APPLICATION NO.	FILING DATE	FIRST NAMED INVENTOR	ATTORNEY DOCKET NO.	CONFIRMATION NO.
10/633,347	08/04/2003	Jerry D. Lowe		3723

Office Action Summary

DETAILED ACTION

FIG. 2

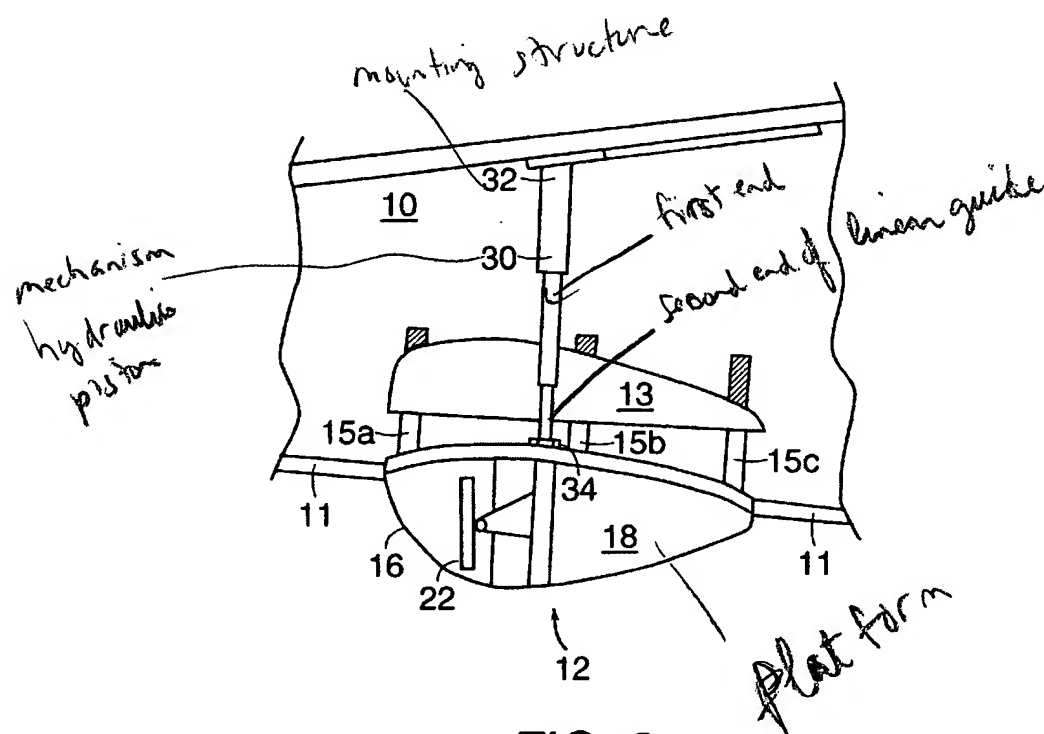
Mackenzie discloses system having a mounting structure within a body. This could be interpreted as element 32. The system has a platform 18 where a camera/sensor 12 is mounted, linear guide (see figure 2), door 13, and mechanism 30 for moving the platform. As for the mechanism that is electrically, magnetically, linear motion screw, or clutch and brake driven, it would have been obvious to one skilled in the art to have used any mechanism that is needed to drive the platform. The applicant has not disclosed the criticality of different mechanisms.

Please note that linear guide is interpreted as the extendable parts with one end connected to the mounting structure (since this part is part of the hydraulic piston) and the other end connected to the platform. See figure 2. Please also see the attached figure 2 with parts being labeled to clearly show what the examiner is interpreting as the parts that are being claimed.

member disposed along and in parallel to a linear movement path of the platform to stabilize and direct linear movement of the platform. Sibley teaches linear guide 32. MacKenzie et al teaches linear guide in figure 2.
